ADA Curb Ramp New Construction Inspection Form (Perpendicular)

Nw 291 st

23885.56

Nw fair st

PERPENDICULAR RAMP (PR)

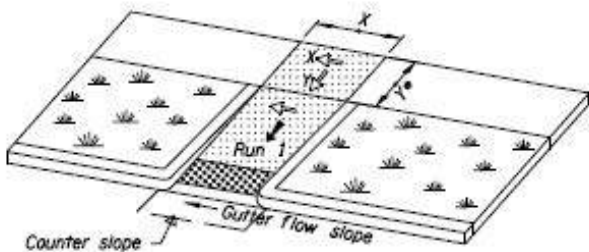
Turn space less than 4 clear width IITD not full width rr1 icrr
